Pre-loaded Reeds - 6 thru 15

Mercury/Mariner

1994 6 thru 15

S/N 0G157511 thru 0G157993

53280

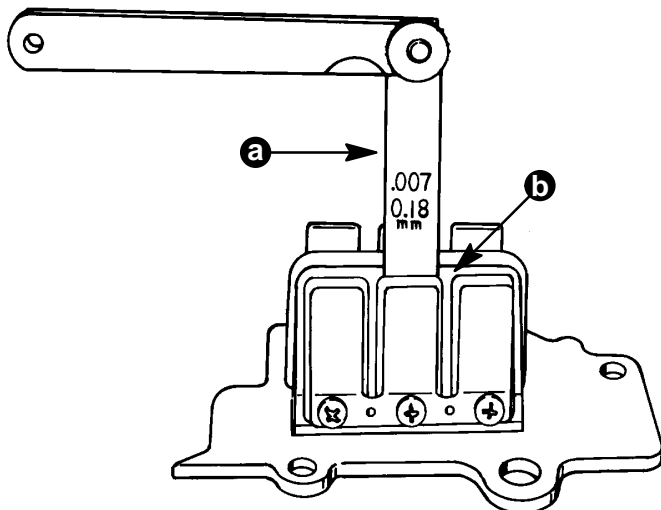
Outboards listed have experienced a condition which required a significant richening of the mixture screw in order to accelerate off idle. The cause of this condition is bent reeds which were assembled to the reed block in the "pre-loaded" direction. This condition could result in poor running qualities or early breaking/chipping of reeds.

1. Install new reeds, p/n 34-825141.
2. Secure reeds and stops to reed block with six screws. Torque screws to 20 lb. in. (2.3N-m).
3. After installation, check reeds for preload and stand open conditions. Stand open should not exceed 0.007 in.(0.178mm).

53202

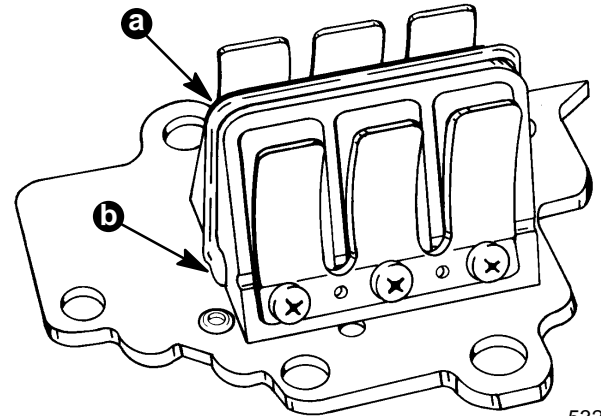
a - Rubber Seal
b - Apply Sealant (Each Side)

4. Replace seal, p/n 26-42137, and apply RTV Sealant (92-91600--1) at each location where seal passes through manifold
5. Reassemble engine and perform carburetor adjustments as outlined in service manual.
